To: Rickelle Williams, City Manager
From: Talal Abi-Karam, Interim Director – Public Works
Date: March 5, 2025
Re: Change Order No. #1 for Design-Build RFP 99 Project # P12384

Job Description: NE 25th Ave 24-Inch Force Main Replacement, and NE 38th St 42-Inch Force Main and NE 19th Ave 24-Inch Force Main Replacement.

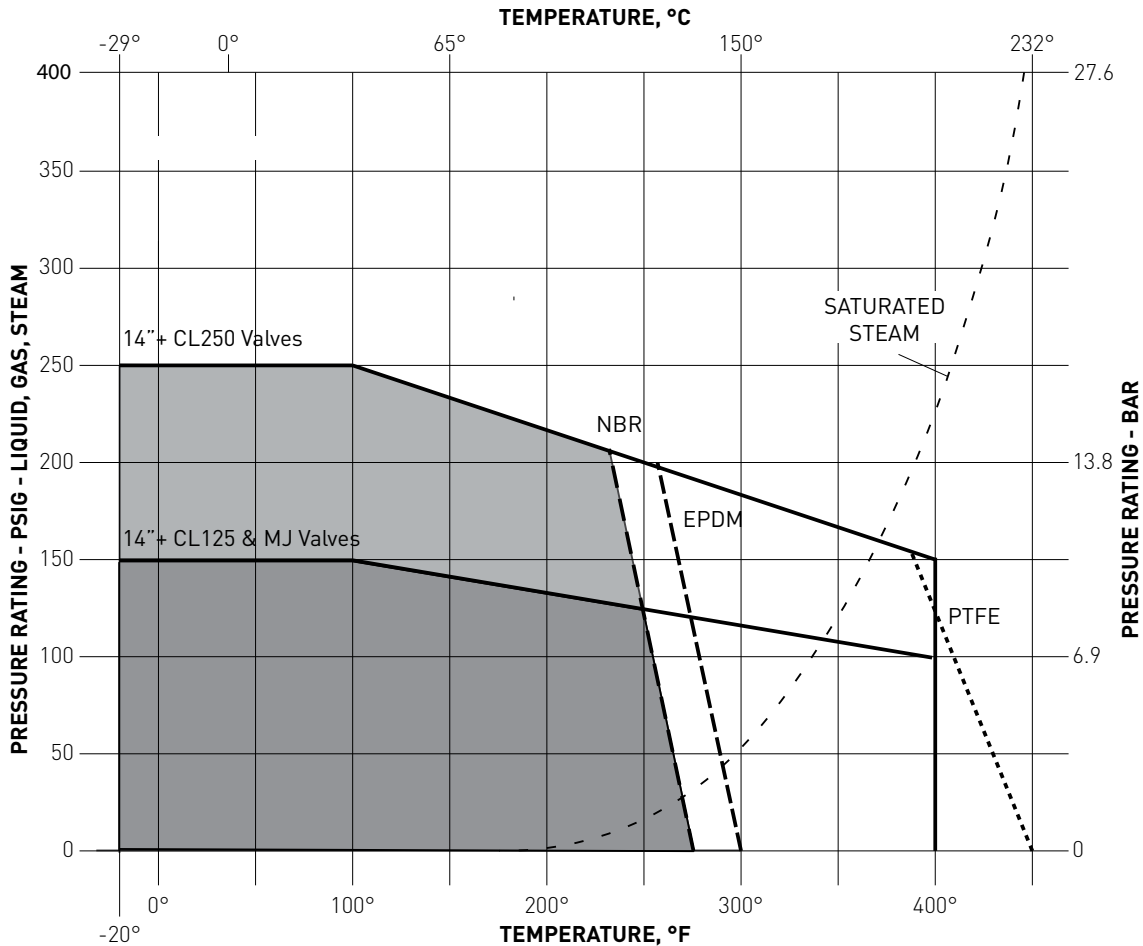
NO EXCEPTIONS TAKEN
REVISE AND RESUBMIT

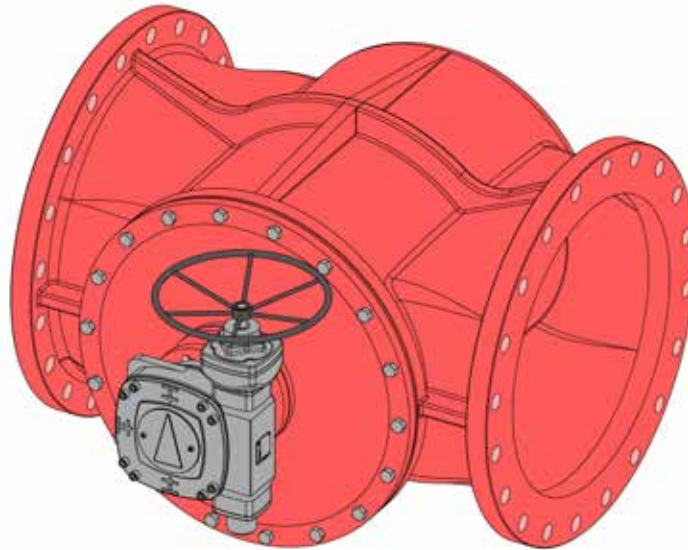
NO EXCEPTIONS TAKEN
 REVISE AND RESUBMIT

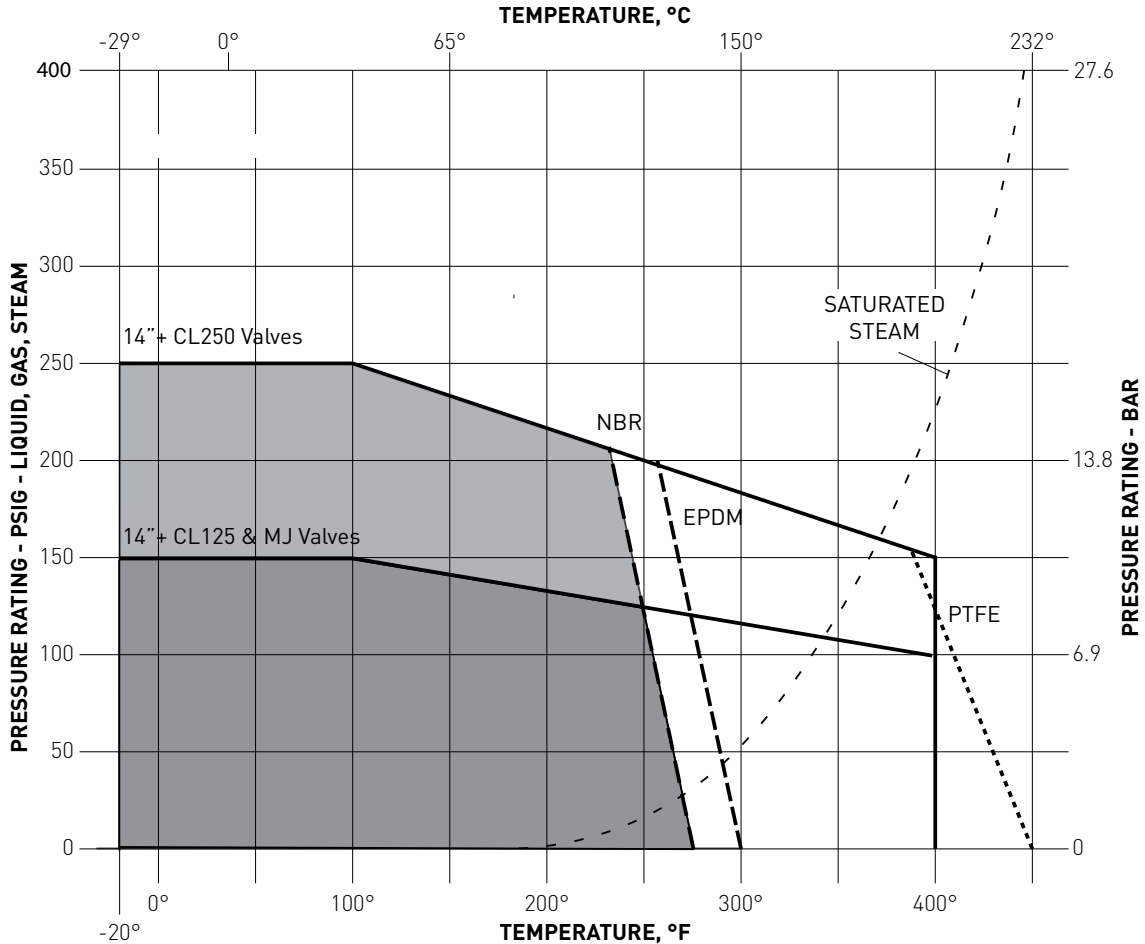
NO EXCEPTIONS TAKEN
 REVISE AND RESUBMIT

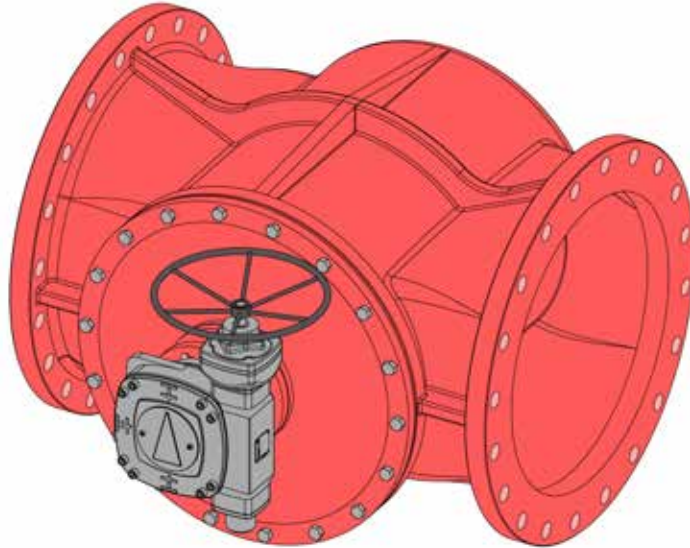
<input checked="" type="checkbox"/> NO EXCEPTIONS TAKEN	<input type="checkbox"/> REVIEW WITH CHANGES
<input type="checkbox"/> REVISE AND RESUBMIT	<input type="checkbox"/> REJECTED

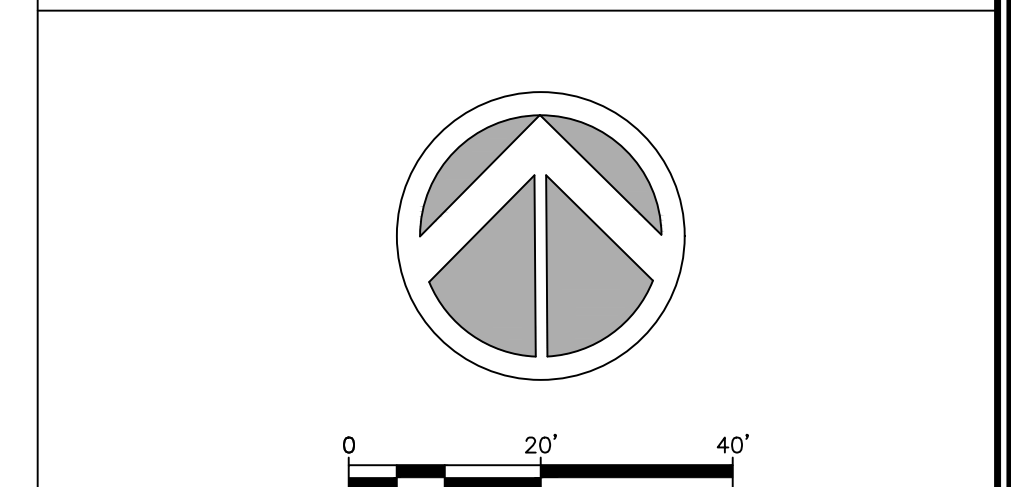
Figure 1: Existing Valve on south side of manifold appears to be in closed position. Labeled as valve 1 in PDF markup.

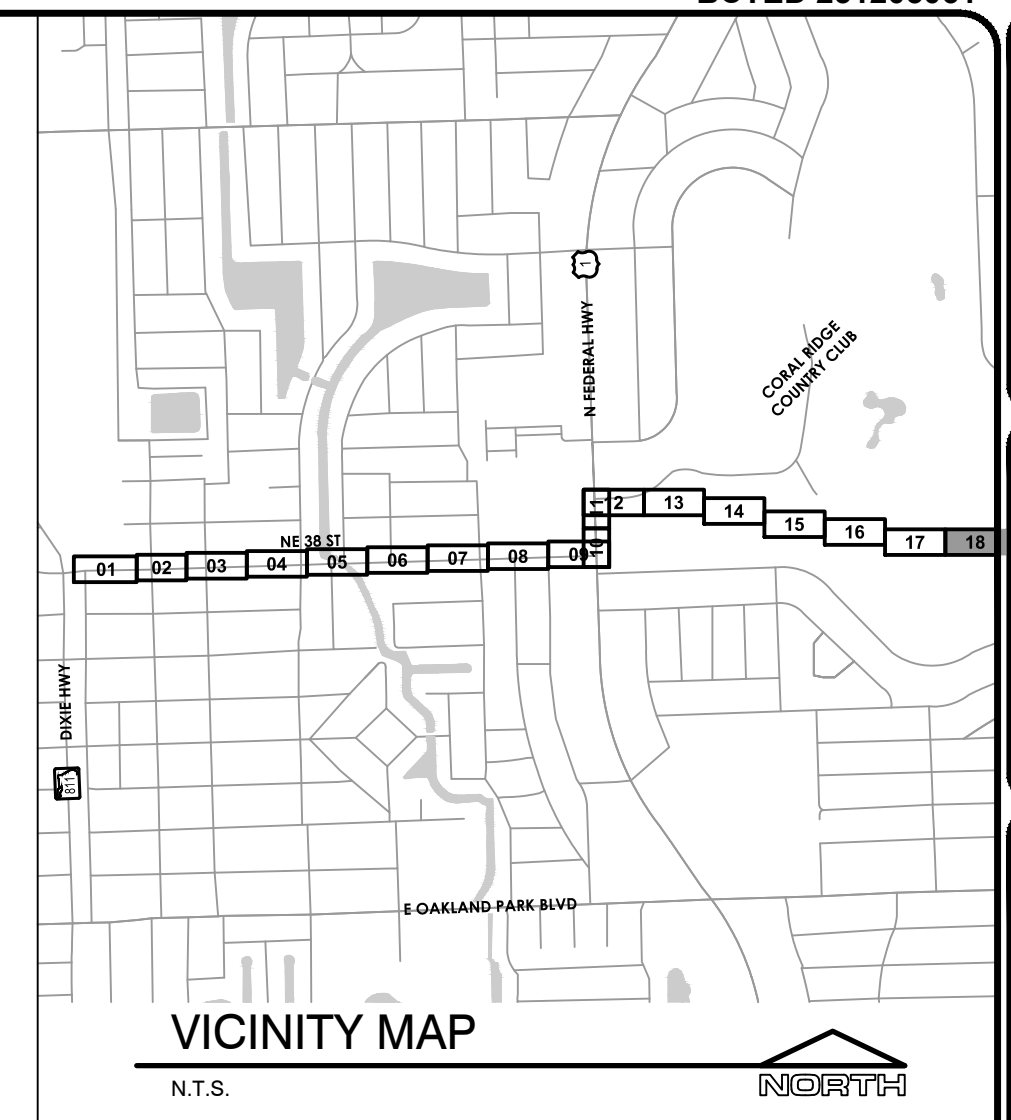
Figure 2: Existing valve on east side of manifold system and open in normal operating conditions letting flow into Repump B. Labeled as valve 2 in PDF markup.
